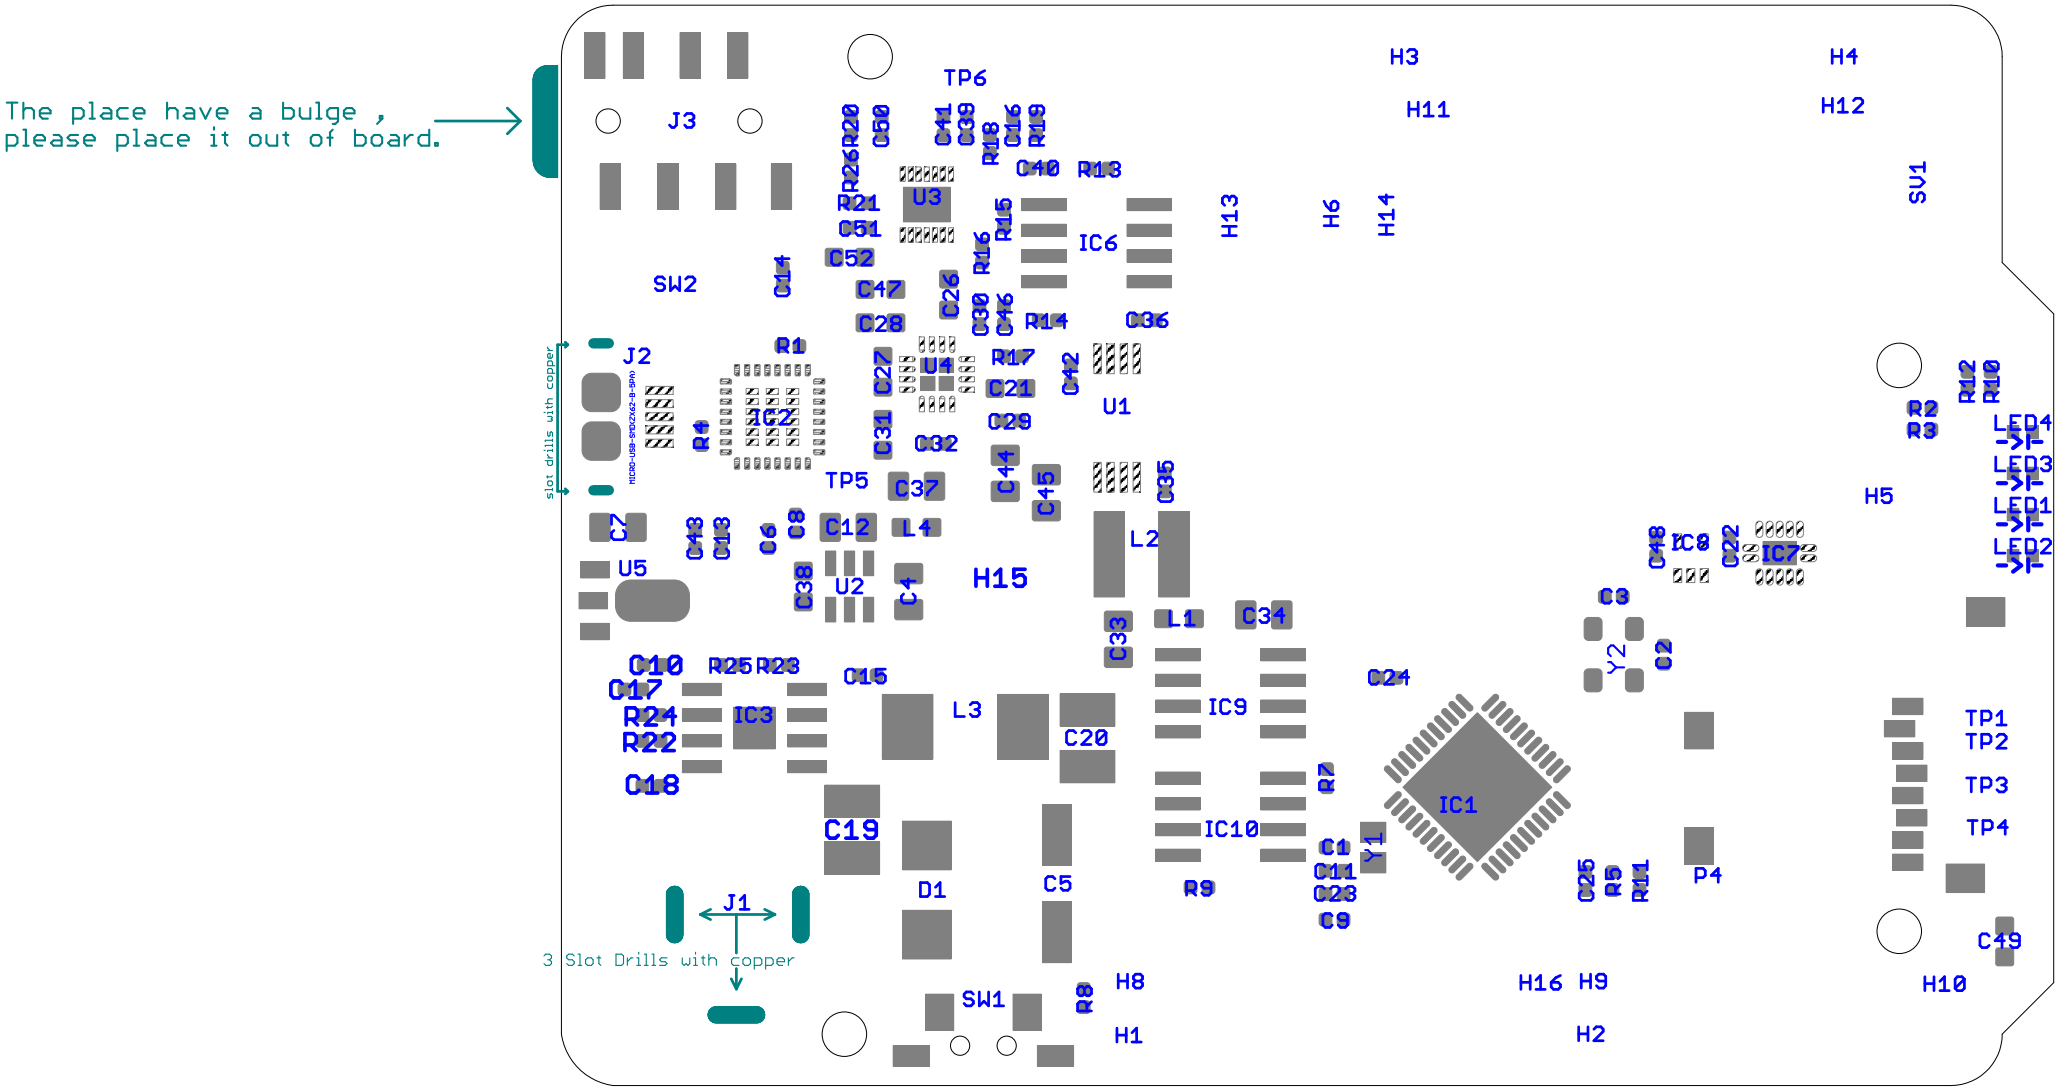
The place have a bulge ,
please place it out of board.
slot drills with copper
3 Slot Drills with copper
J1
J2
J3
SW1
SW2
TP5
TP6
U1
U2
U3
U4
U5
IC1
IC2
IC3
IC6
IC7
IC9
IC10
L1
L2
L3
D1
Y1
Y2
P4
SV1
H1
H2
H3
H4
H5
H6
H8
H9
H10
H11
H12
H13
H14
H15
H16
LED1
LED2
LED3
LED4
TP1
TP2
TP3
TP4
